**SUBJECT: Comment Response Letter – Bent Grass Residential Filing No. 2 (SF-19-014)**

Please see the following responses in ***bold and italics*** for the 1<sup>st</sup> review of Bent Grass Residential Filing No. 2.

## BENT GRASS MEADOWS DRIVE STORM PLAN & PROFILE

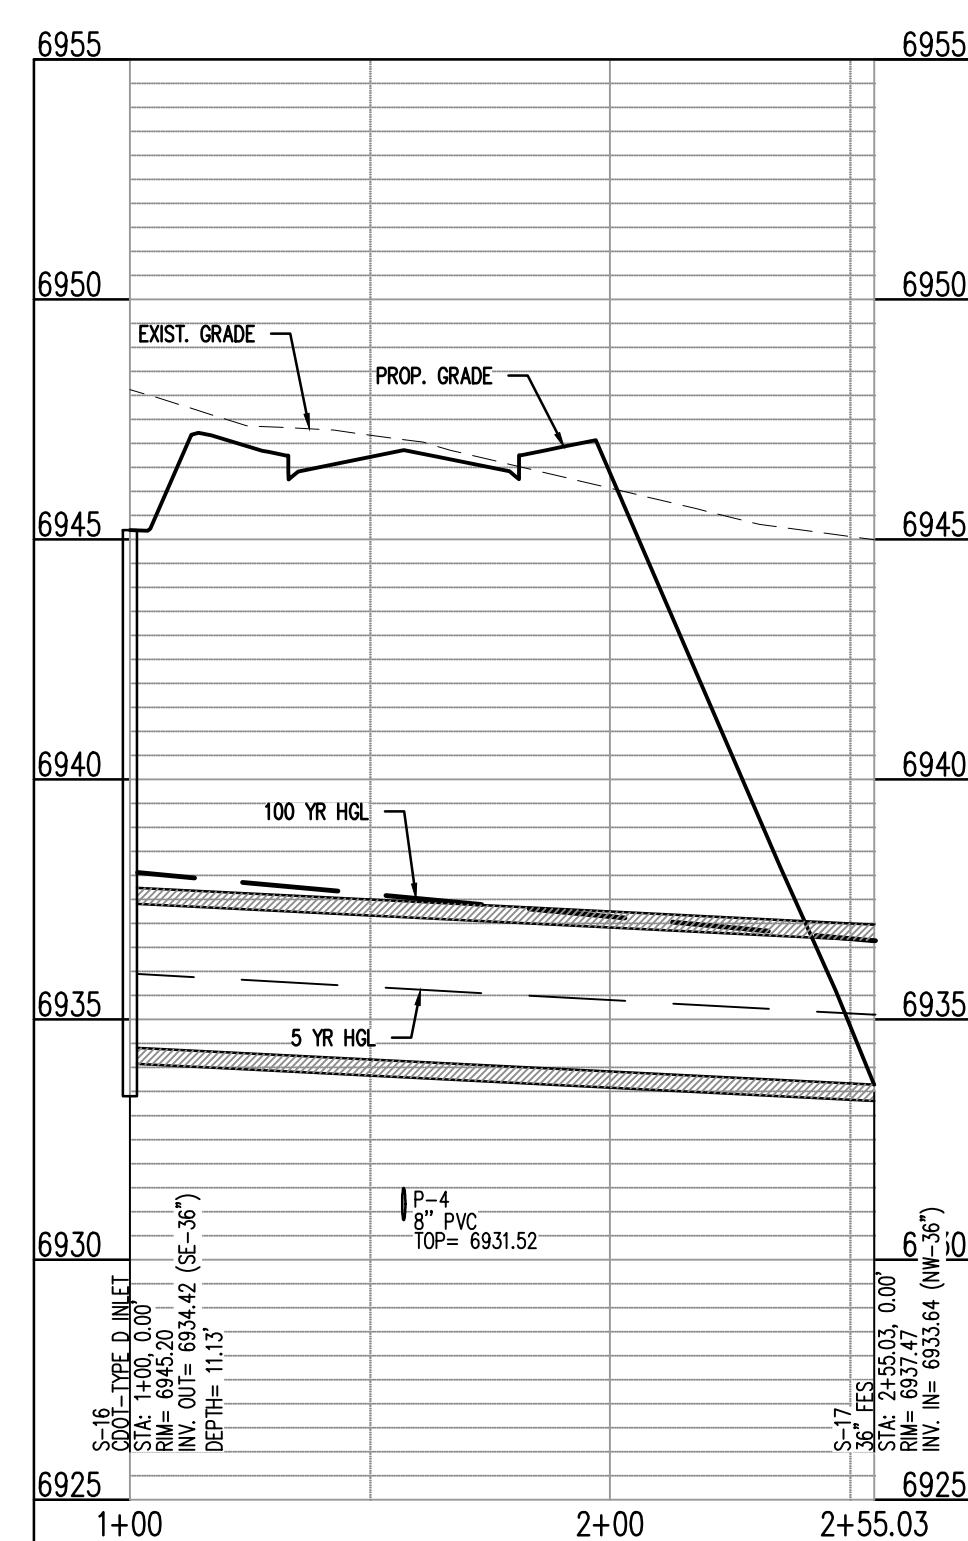
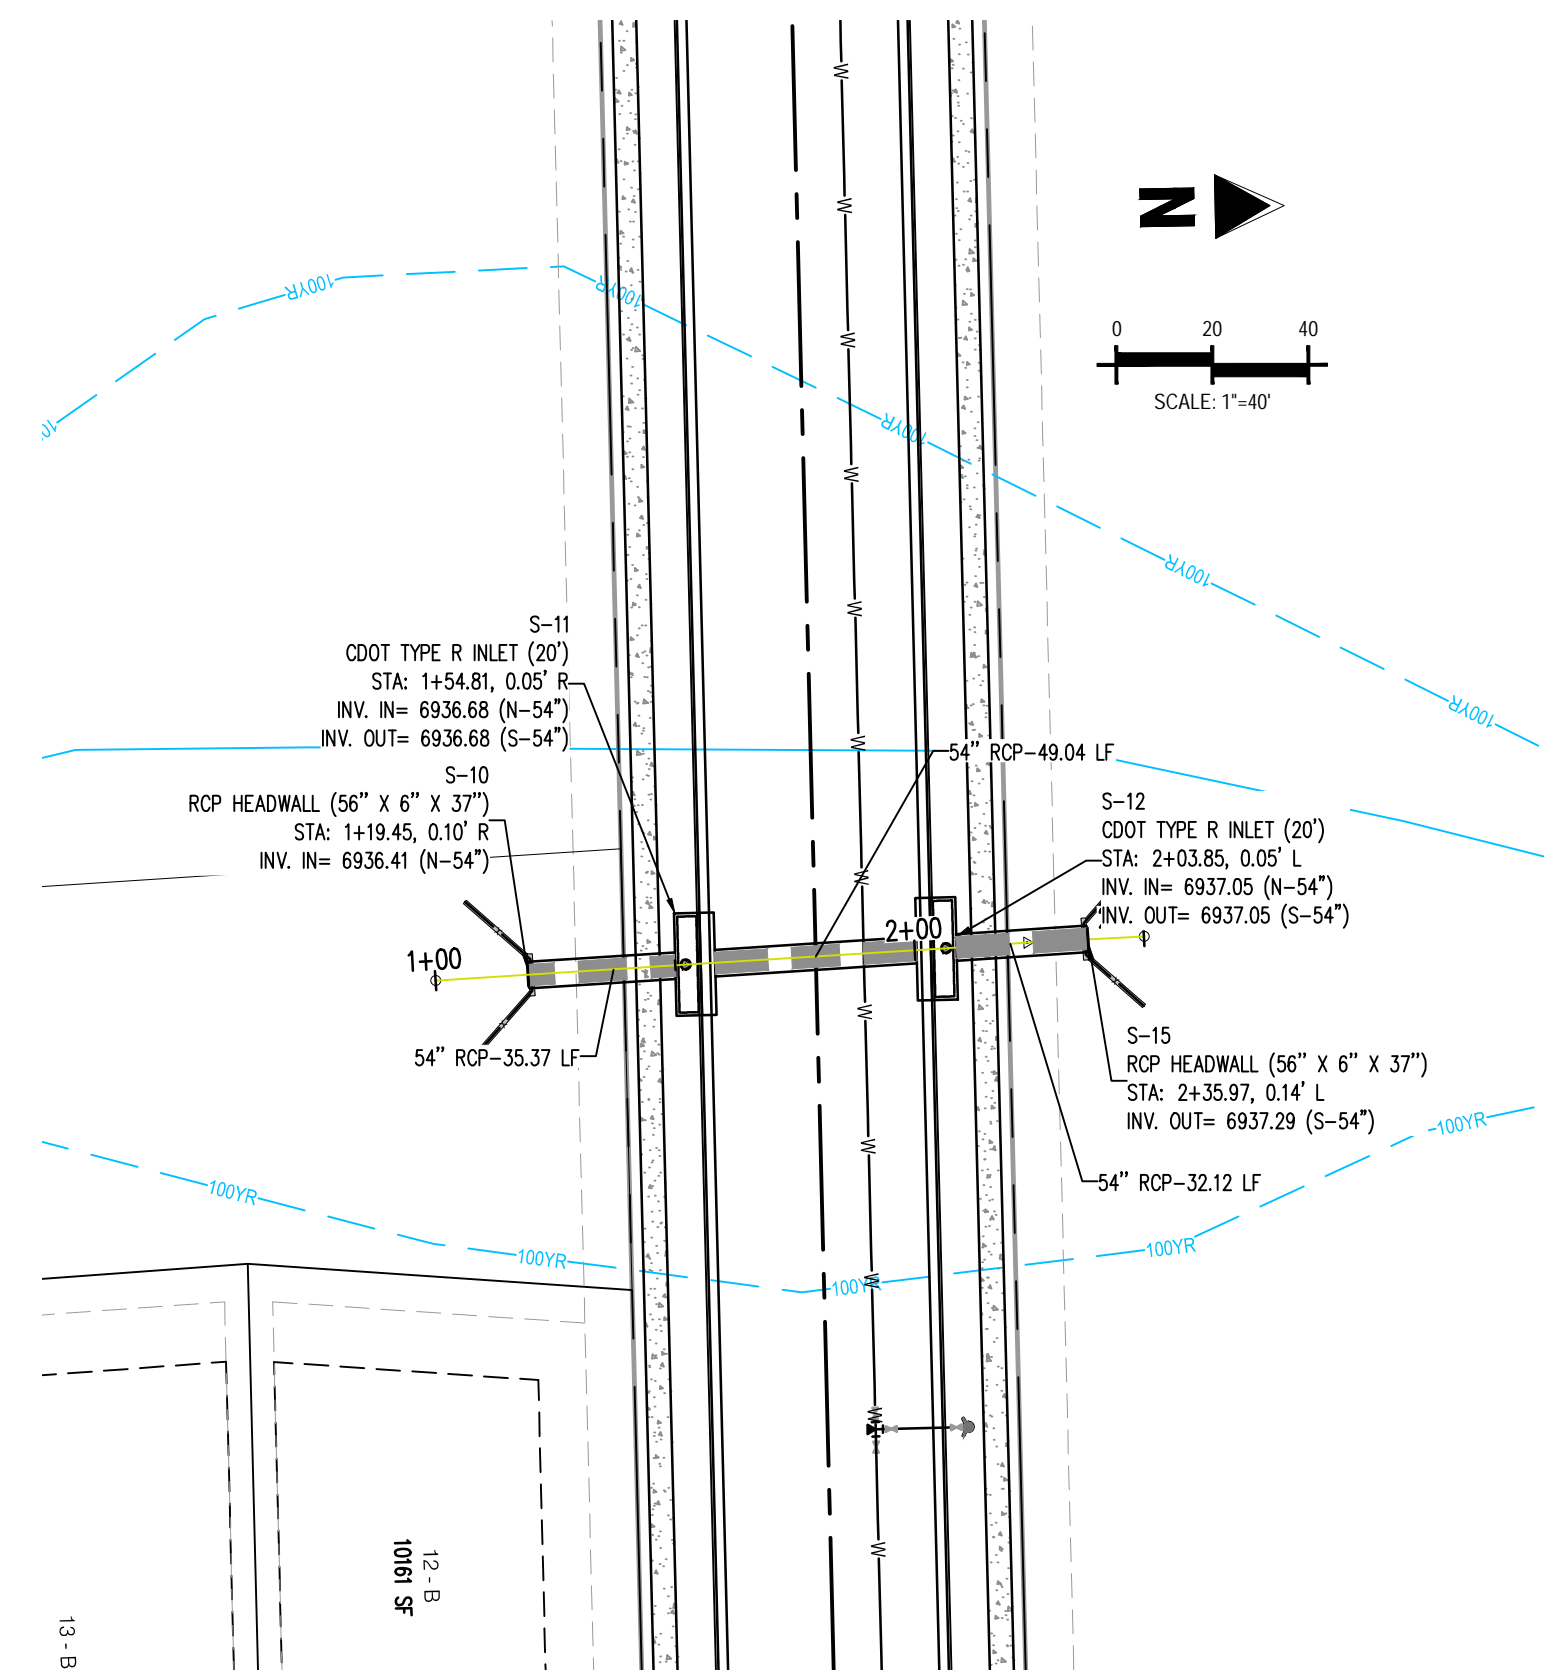
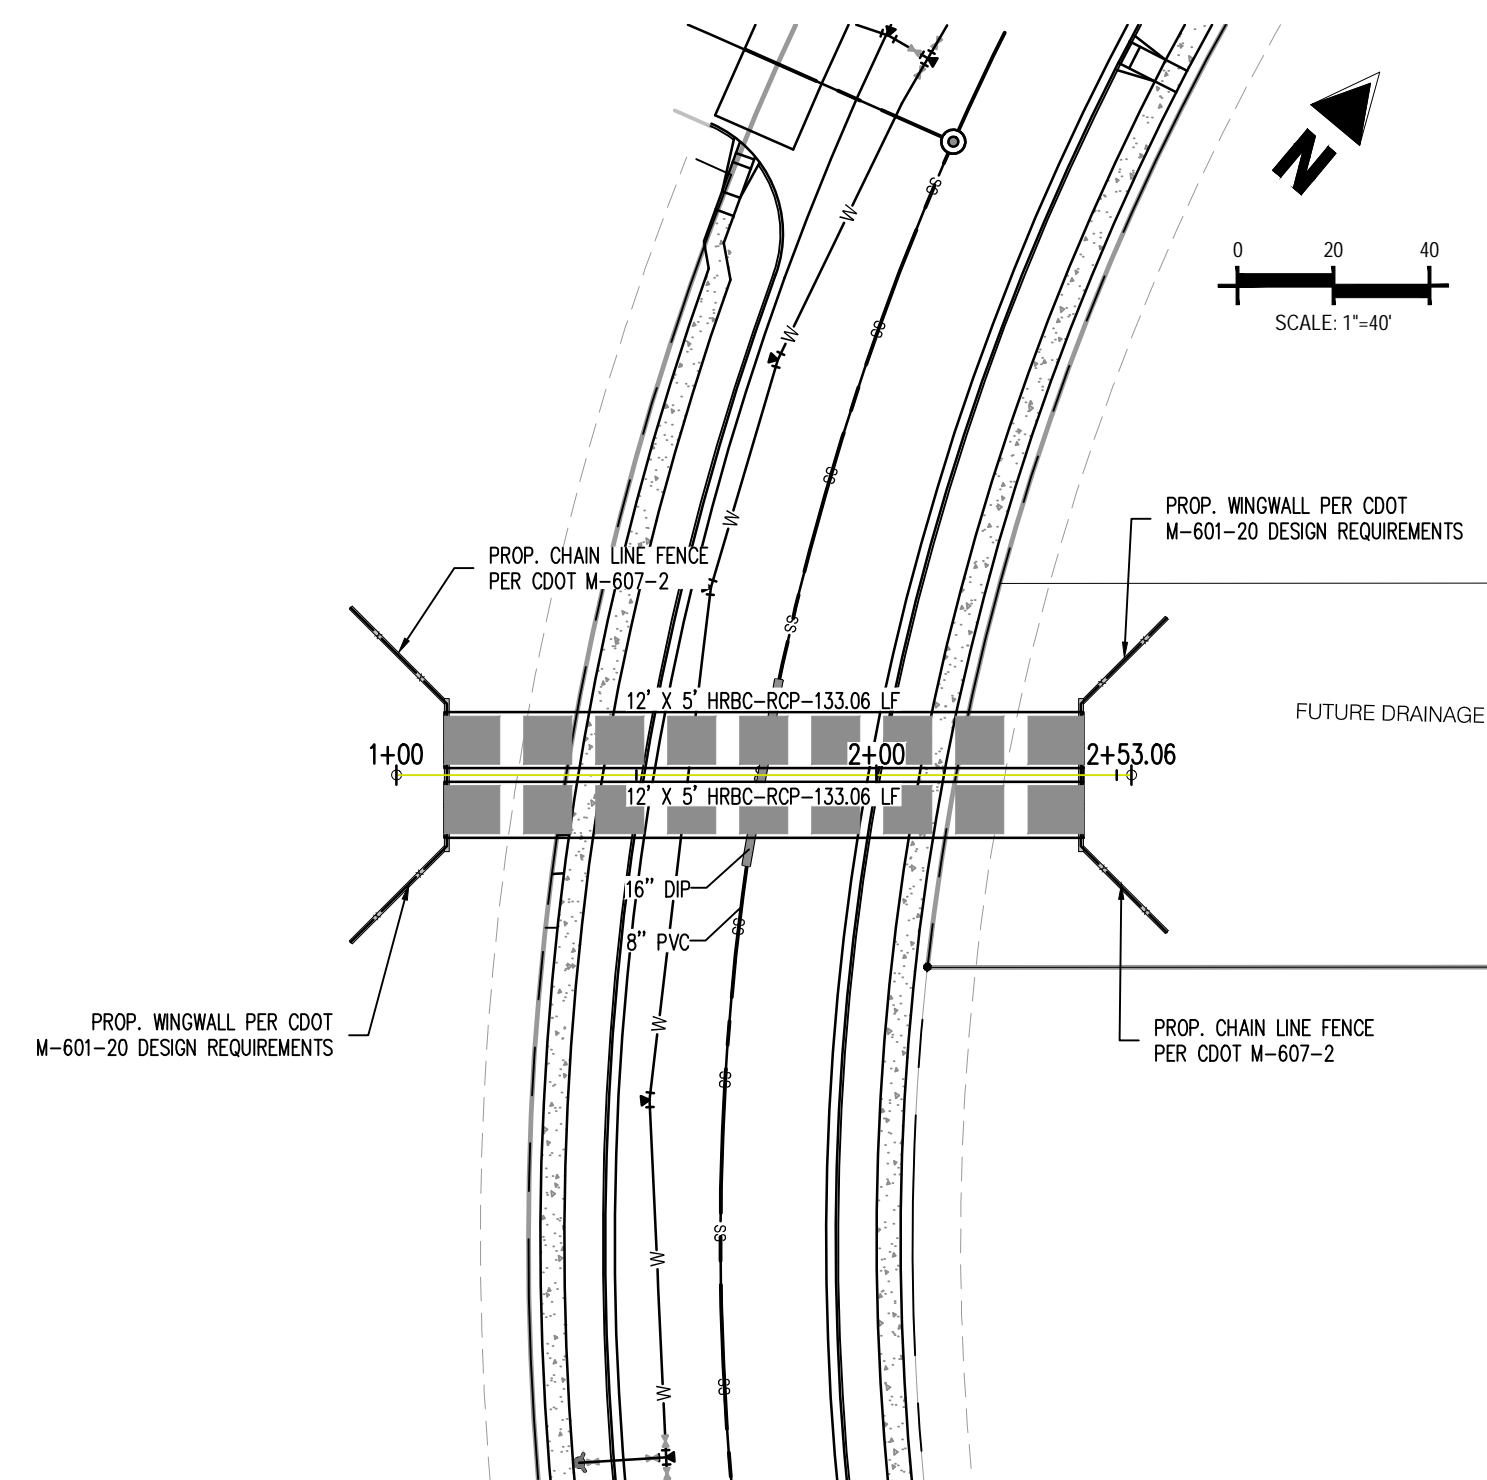
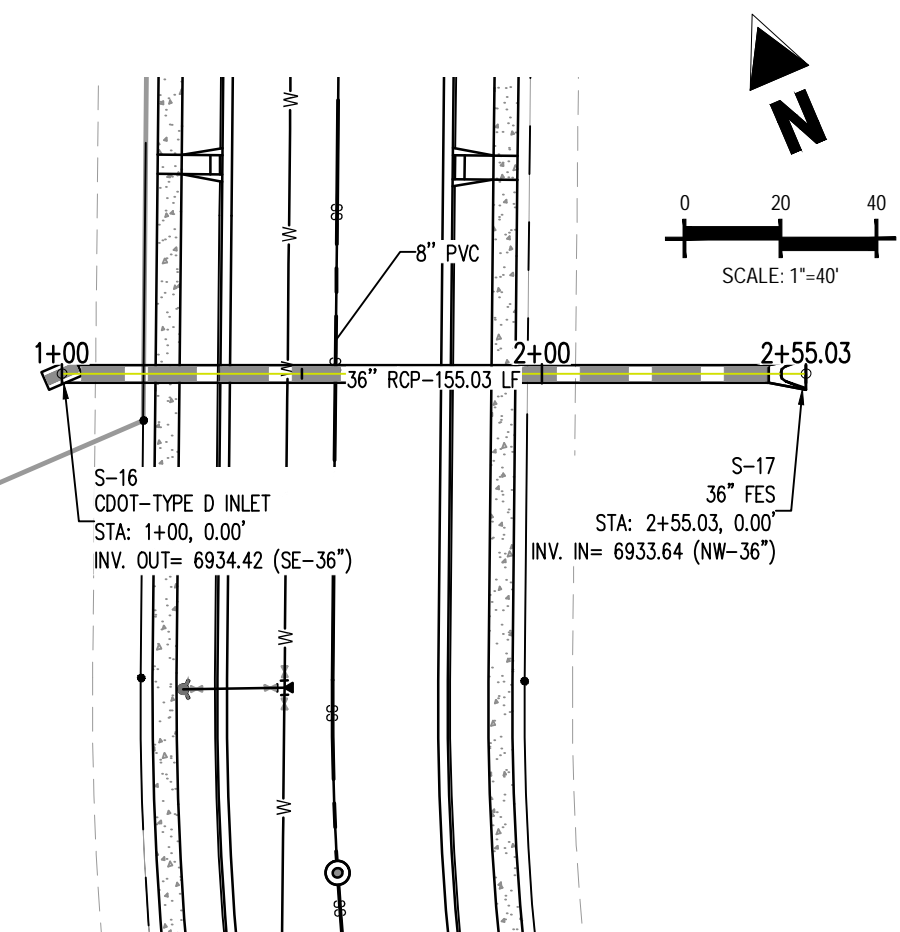
Show the outfall,  
Rip rap dissipater?  
Property lines?  
Where the bottom of the  
channel is?  
etc. ?  
Easements?  
Public or private &  
maintenance entity?

Added detail to this sheet and other storm plan sheets. Also see GEC Plans for Rip Rap Dissipater (Storm Pipe Outfall)
